8. Well Name and No.
GALLEGOS CANYON UNIT 349. API Well No.
30-045-07144-00-S110. Field and Pool or Exploratory Area
BASIN FRUITLAND COAL
TAPACITO PICTURED CLIFFS11. County or Parish, State
SAN JUAN COUNTY, NM**SUBMIT IN TRIPLICATE - Other instructions on page 2**

PLUG AND ABANDONMENT PROCEDURE

Gallegos Canyon Unit #034

CONDITIONS OF APPROVAL

Proposed P&A

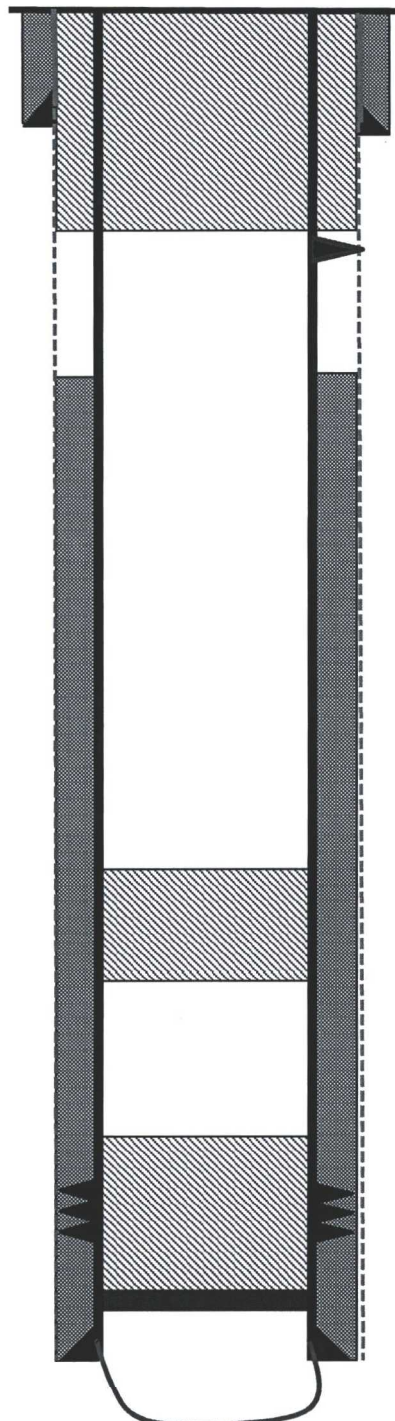
Plug #2: 995' - 895'

- a) Set Plug #2 (1118-1018) ft. to cover the Fruitland top. BLM picks top of Fruitland at 1068 ft.
